## Planning Commission Agenda Item

**SUBJECT:** CUP16-01 Amendment to Conditions for Starbucks Coffee Drive-Thru

### **AGENDA ITEM NO. 1**

A request by staff for Planning Commission consideration of an amendment to the approved Conditions of Approval for CUP 16-01 relating to a street tree and a stormwater filter in the public right-of-way. The project site is 0.40 acres and is located at 400 East Ocean Avenue in the *Commercial Office (CO)* Zoning District. This action is exempt pursuant to Section 15061 of the California Environmental Quality Act (CEQA).

**Figure 2: Ocean Avenue Frontage Plan**

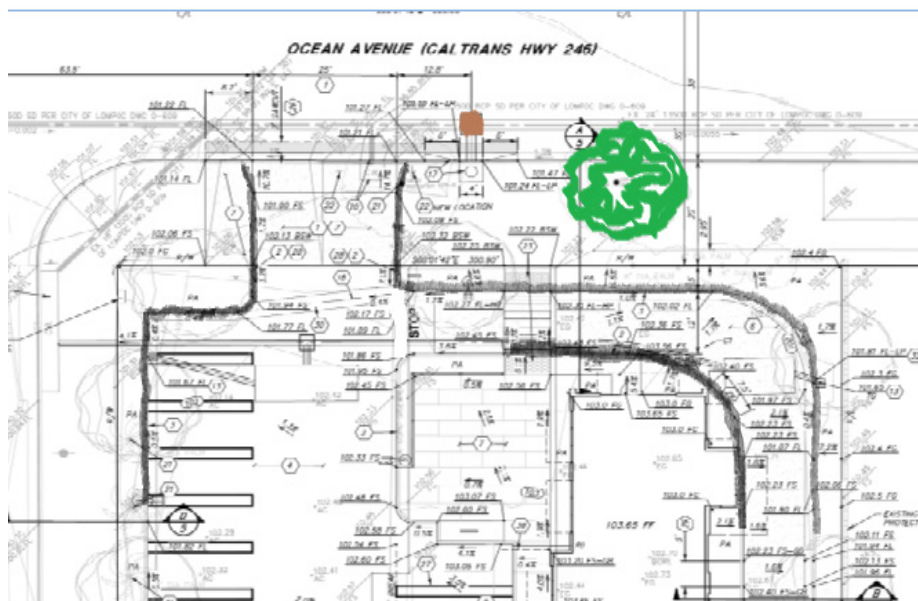
Stormwater Condition of Approval S5 requires the storm drain inlet (Shown in Figure 2 below), that was to be relocated on East Ocean Avenue, be properly fitted with a storm water filter that filters out trash, sediment, oil and grease.

During construction, the applicant's contractor determined Caltrans does not generally allow storm drain inlet filters to be placed in Caltrans' right-of-way inlets.

The applicant's engineer provided a copy of a letter dated August 28, 2017 (Attachment 1), from the Caltrans District 5 Department of Transportation Encroachment Permit Office, which do not install a catch basin filter within the State right-of-way.

Staff has verified with Caltrans District 5 National Pollutant Discharge Elimination System (NPDES) Coordinator Pete Riegelhuth that "...storm water filters are not approved for use on the State highway system." He states "They tend to plug up if not maintained and put the traveling public at risk due to flooding."

Again, given the City does not have jurisdiction within the Caltrans right-of-way, and Caltrans is subject to its own separate statewide NPDES permit, staff recommends the Planning Commission modify Stormwater Condition of Approval P51, on the basis of infeasibility, to be amended as follows:

- S5. All storm water that flows from paved areas of vehicle travel, maintenance, parking or uncovered outdoor storage, shall be filtered for trash, sediment, oil and grease, prior to discharge into City streets, storm drains, infiltration SCMs, landscaped area, biologically sensitive areas or the Santa Ynez River and its tributaries. Storm drain inlets within the site ~~and the relocated street curb inlet on Ocean Avenue~~ shall have properly installed filters meeting these requirements. Trash filters shall be of the type required by the City and the State Water Resources Control Board at the time of plan approval. Grading and Drainage plans submitted shall provide inlet details and filter details and cross-sections.

State Standard Plan A87A

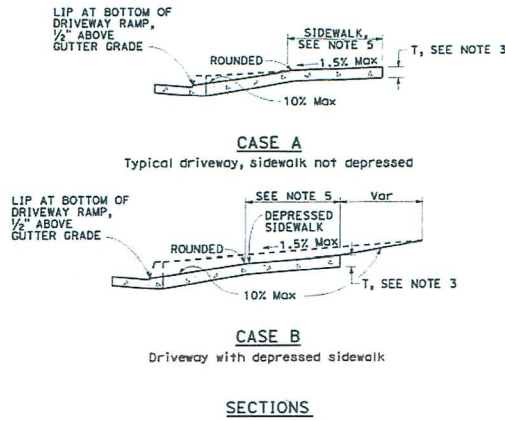
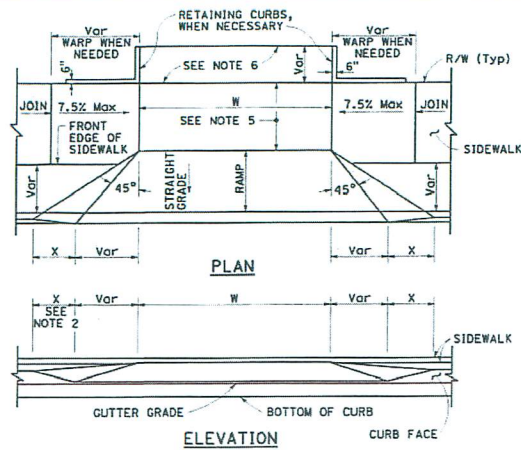
1. Driveway ramp grades exceeds the State's maximum grade of 10.0%. Revise driveway ramp design to comply.
2. State Standard Plan for an urban driveway approach has a 45 degrees flare before transitioning the curb to full height. See attached standard plan A87A. Revise plans as necessary.
3. Provide a dimension for the depth of driveway ramp or sidewalk width behind the driveway ramp.
